ARCHITECTURAL REVIEW BOARD MEETING

JUNE 25, 2024 IN THE CITY COUNCIL CONFERENCE ROOM AT 5:00 PM

PLANNING AND ZONING COMMISSION CASE MEMO

TO: Planning and Zoning Commission
DATE: June 25, 2024
APPLICANT: Dub Douphrate; *Douphrate & Associates, Inc.*
CASE NUMBER: SP2024-023; *Site Plan for Crosspoint Church*

1 ELEVATION 3
A.302 1/8" = 1'-0"

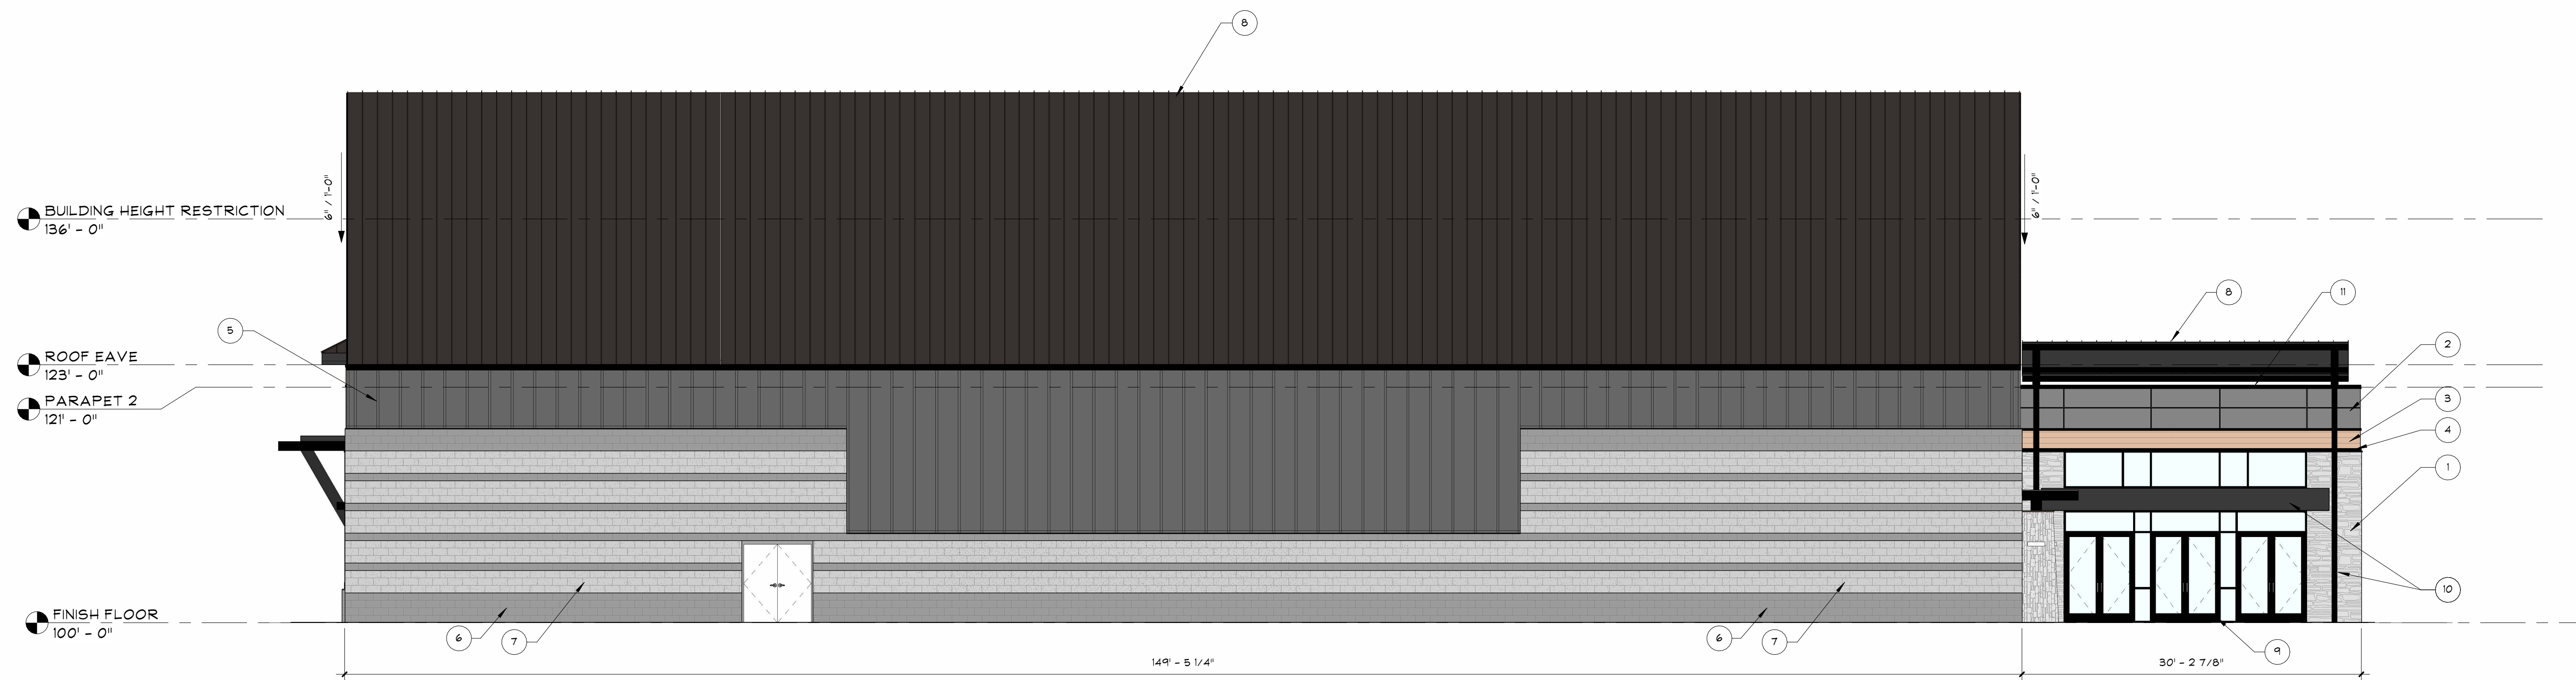
- (1) *Articulation*. According to Subsection 04.01(C), *Building Articulation*, of Article 05, *District Development Standards*, of the Unified Development Code (UDC), all building facades shall meet the minimum primary and secondary articulation requirements outlined in *General Commercial District Standards*, and depicted in *Figure 7, Commercial Building Articulation Standards*, of Article 05, *District Development Standards*, of the Unified Development Code (UDC). In this case, each façade of the proposed buildings do not meet this requirement. This will require an exception from the Planning and Zoning Commission.

04 EXTERIOR ELEVATION - OVERALL - EAST
1" = 20'-0"

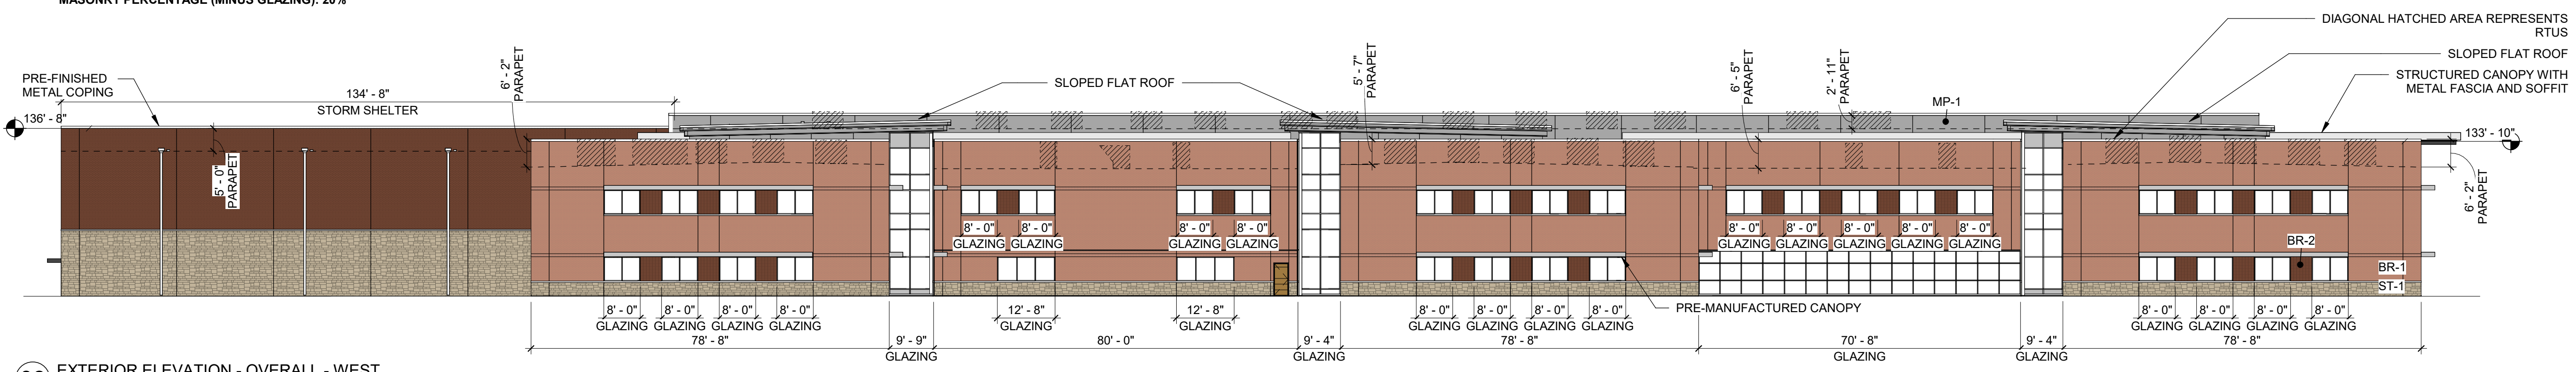
- (a) Masonry Materials. According to Subsection 06.02(C)(1), *Materials and Masonry Composition*, of Article 05, *District Development Standards*, of the Unified Development Code (UDC), "(e)ach exterior wall of a building's façade shall consist of a minimum of 90% Primary Materials..." Primary materials include brick, stone, and cementitious materials. In this case, each façade of the proposed building does not meet this requirement. This will require a variance from the Planning and Zoning Commission.

- (b) Stone. According to Subsection 06.02(C)(1), *Materials and Masonry Composition*, of Article 05, *District Development Standards*, of the Unified Development Code (UDC), "(a) minimum of 20% natural or quarried stone is required on all building façades..." In this case, each façade of the proposed building does not meet this requirement. This will require a variance from the Planning and Zoning Commission.
